Final Environmental Impact Report  
**71 Stevenson Street**

State Clearing House Number 82101915

# Final Environmental Impact Report

## **71 Stevenson Street**

● FIGURE 7A: Land Use Map

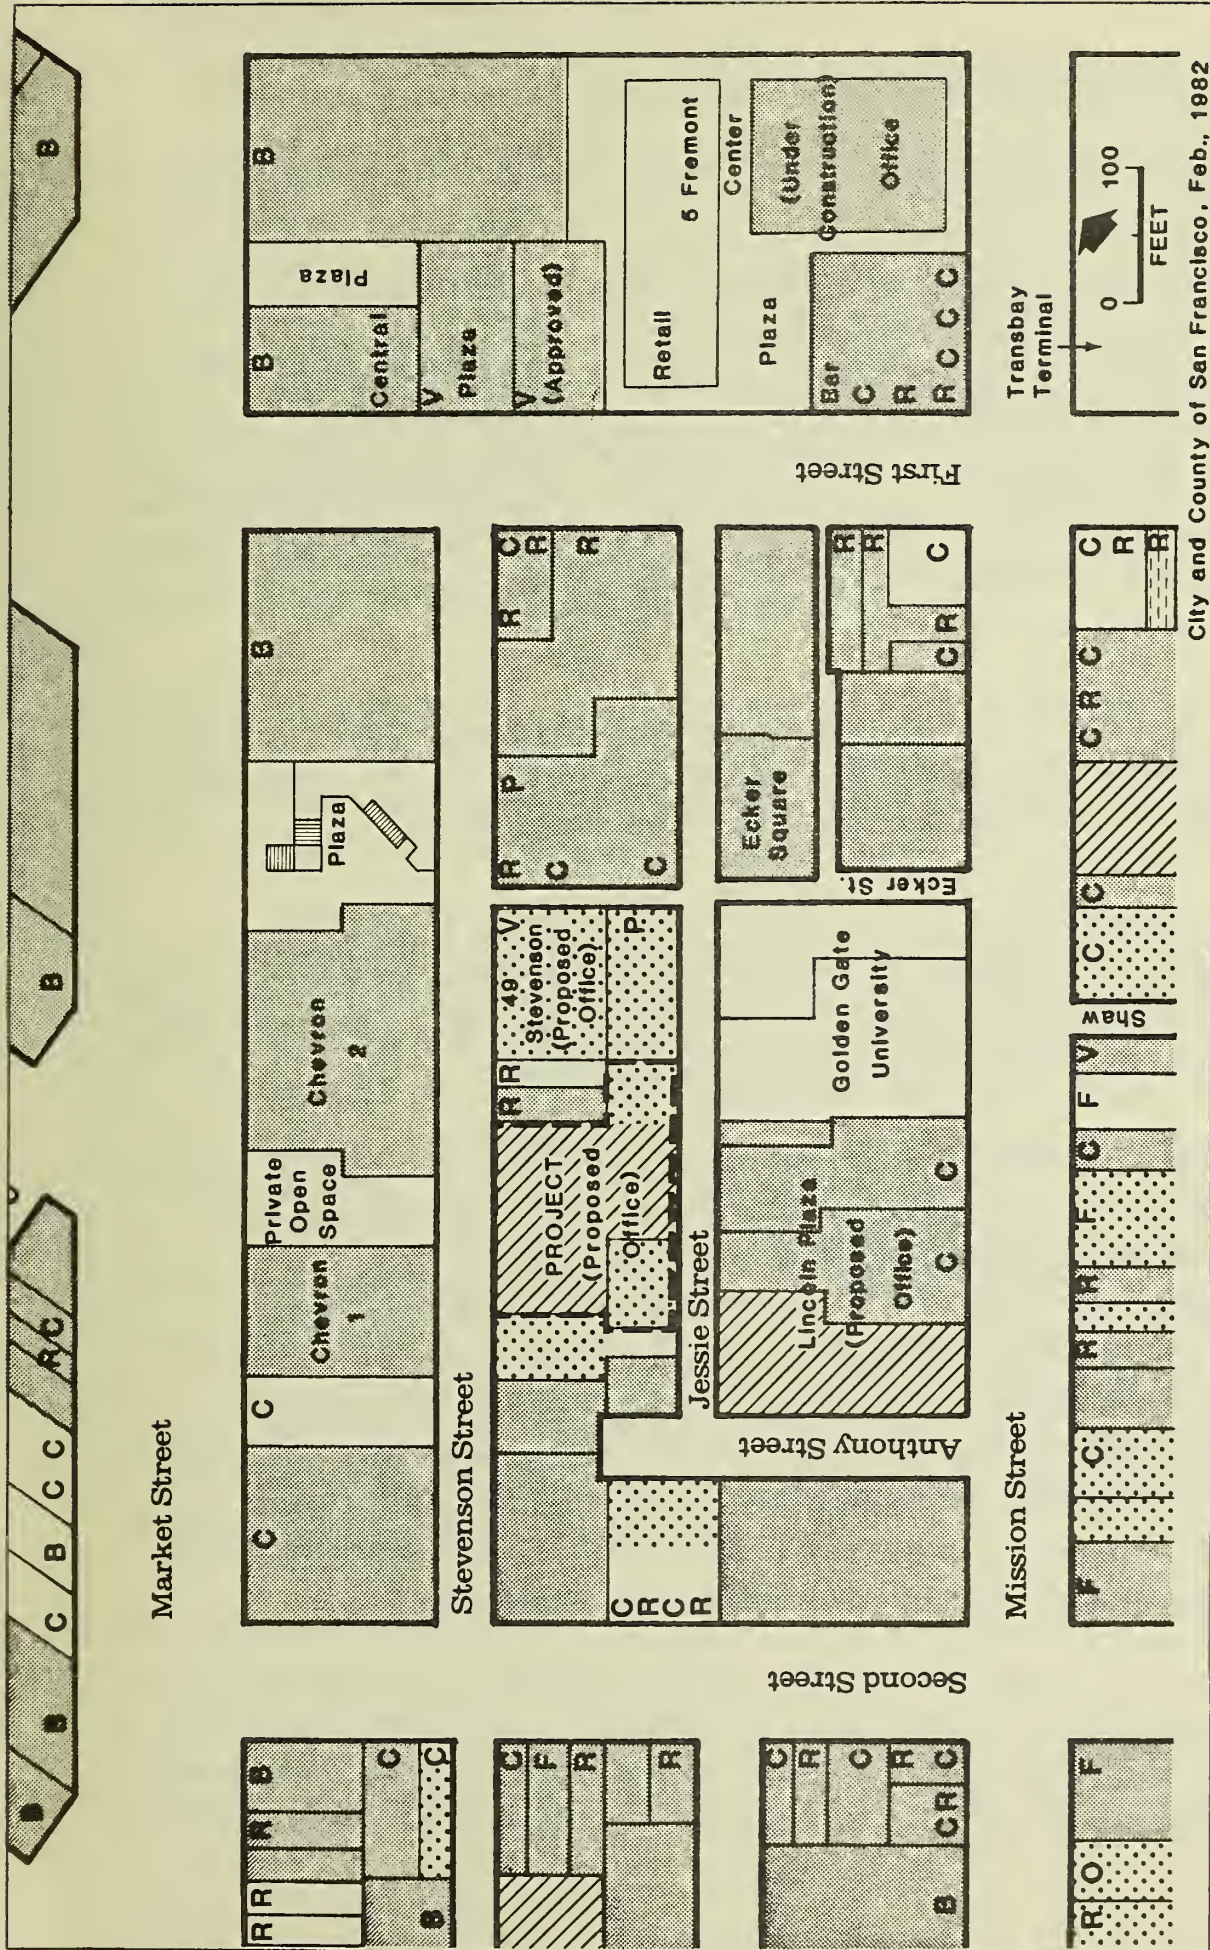
"(see Figure 7a, p. 17a)".

Figure 7a, Land Use in the Project Vicinity, has been added to the EIR as p. 17a, and is included here as p. 204.
